UNITED STATES
NUCLEAR REGULATORY COMMISSION
WASHINGTON, D. C. 20555

Subject: Issuance of Amendment No.60 to Facility Operating License NPF-9 and
Amendment No.41 to Facility Operating License NPF-17 - McGuire
Nuclear Station, Units 1 and 2

SAFETY EVALUATION BY THE OFFICE OF NUCLEAR REACTOR REGULATION
RELATED TO AMENDMENT NO. 60 TO FACILITY OPERATING LICENSE NPF-9
AND AMENDMENT NO. 41 TO FACILITY OPERATING LICENSE NPF-17

McGUIRE NUCLEAR STATION, UNITS 1 AND 2

FIGURE 3.1-0
MODERATOR TEMPERATURE COEFFICIENT VS POWER LEVEL

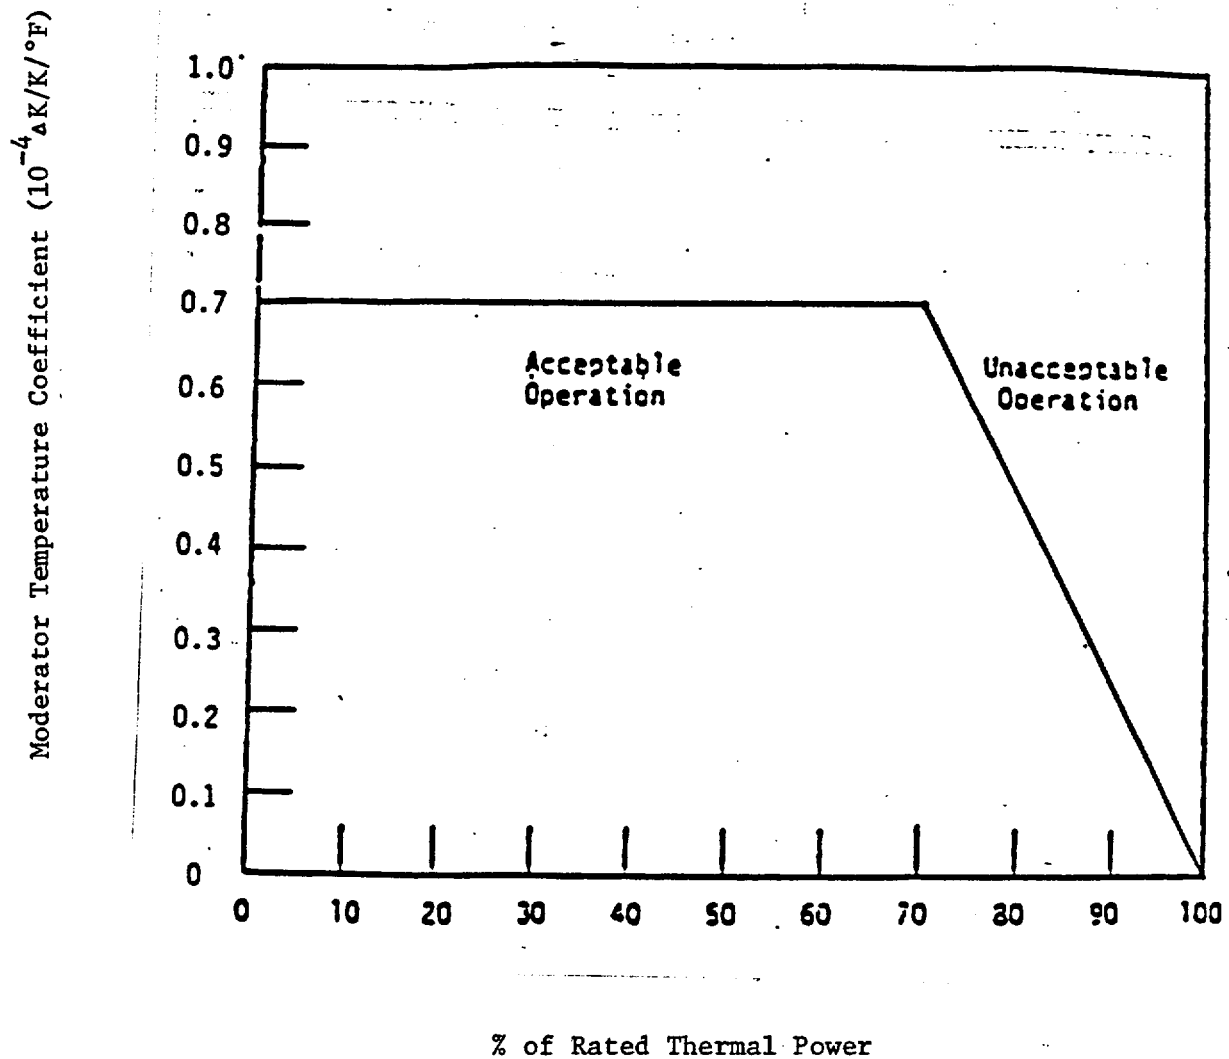
The reload for Cycle 4 reflects the third in a series of four refueling stages for Unit 1 associated with the transition to the use of Optimized Fuel Assemblies (OFA) at McGuire Nuclear Station. The transition began with the Unit 1 refueling for Cycle 2 which was authorized April 20, 1984, by License Amendment 32 (Ref. 2). The TS change for Unit 1 only involves revision of permissible Axial Flux Difference (AFD) limits for Relaxed Axial Offset Control (RAOC) for Cycle 4. The previous TS figure for AFD limits is retained, but for Unit 2 only. The change applicable to both units consists of increasing the allowable positive Moderator Temperature Coefficient (MTC). Prior to these amendments, the TS allowed a +5 pcm/°F MTC at power levels up to 70%, and 0 at power levels above 70%. The revised TS allows an MTC of +7 pcm/°F up to 70%, decreasing linearly above 70% power to 0 pcm/°F at 100% power.

A more positive MTC than the current value is specified for Cycle 4. This is evaluated elsewhere in this SER.

Since the reanalysis of the affected plant transients does not result in exceeding any of the fuel limits or safety limits specified in the previously approved reference or FSAR analyses, we conclude that operation with the specified positive moderator temperature coefficient (i.e., a coefficient of +7 pcm/°F up to 70% power, and decreasing linearly from this to 0 pcm/°F at full power) will not pose an undue risk to the health and safety of the public, and is therefore acceptable. The analysis is applicable to both McGuire Units 1 and 2, and therefore the proposed revision of the TS to incorporate the MTC for both units is acceptable.

Figure 3.2-1a

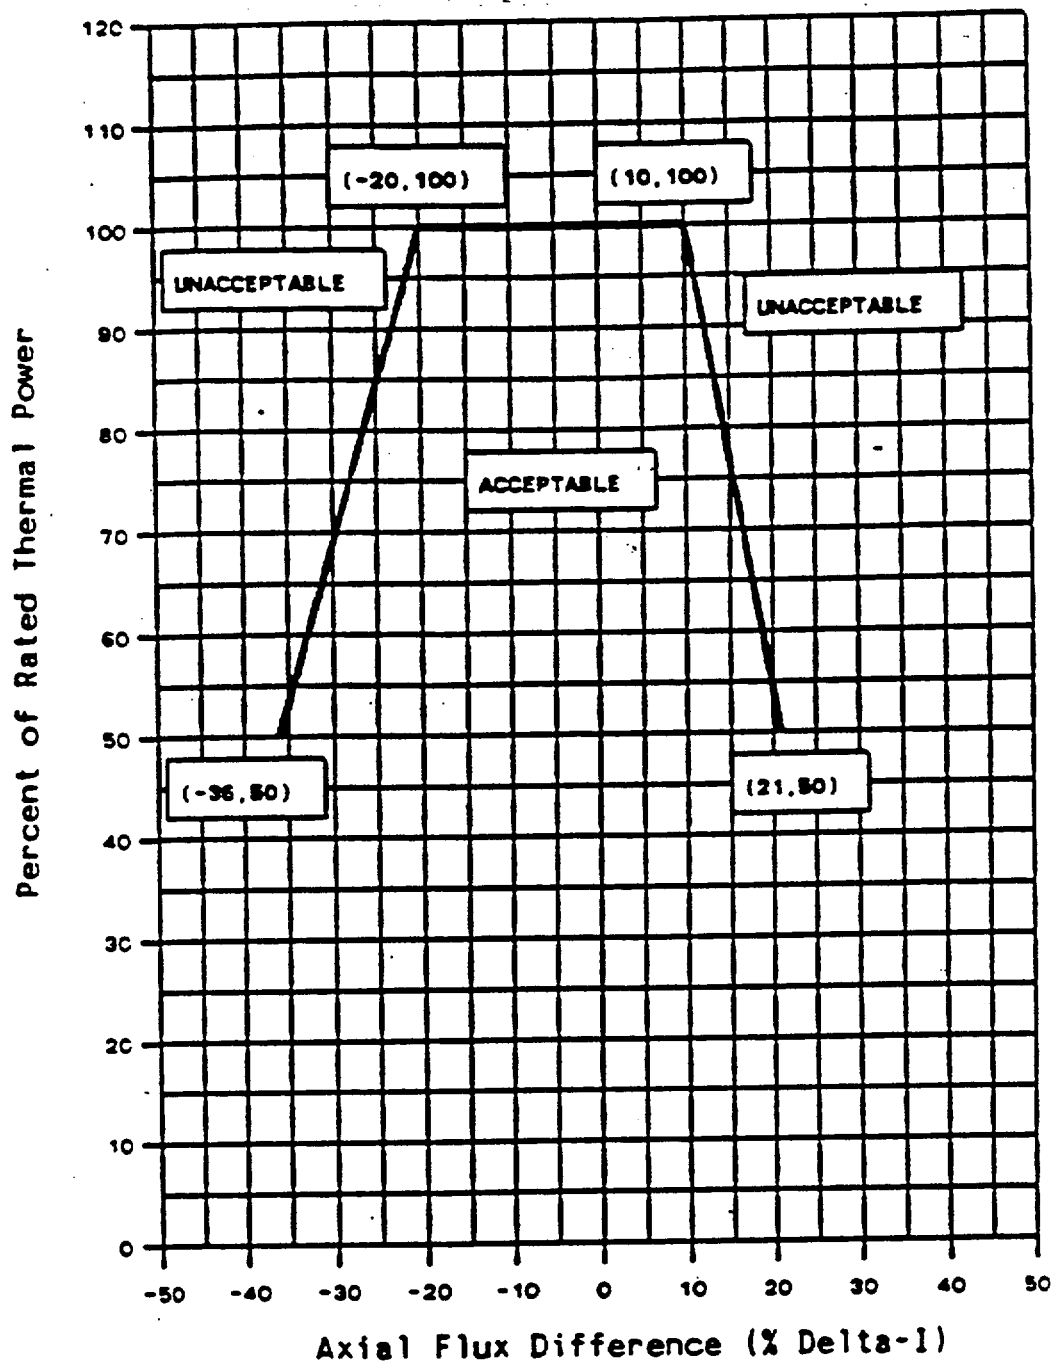
The Cycle 4 core loading is designed to meet $[F_0(z) \times P]$ ECCS limit of $\leq 2.26 \times K(Z)$. The cycle-specific RAOC analysis based upon the above $F_0(z)$ limits results in a new curve of AFD limits as a function of power. This was submitted as a change to TS Figure 3.2-1a for Unit 1 only. Since this figure was calculated with approved RAOC methods (Ref. 8) and maintains the above $F_0(Z)$ limits approved for Cycle 3 (Ref. 7), the change to TS Figure 3.2-1a is acceptable. The previous Figure 3.2-1 continues to apply to Unit 2, and is redesignated "Figure 3.2-1b (Unit 2)". This change is purely administrative and is, therefore, also acceptable.
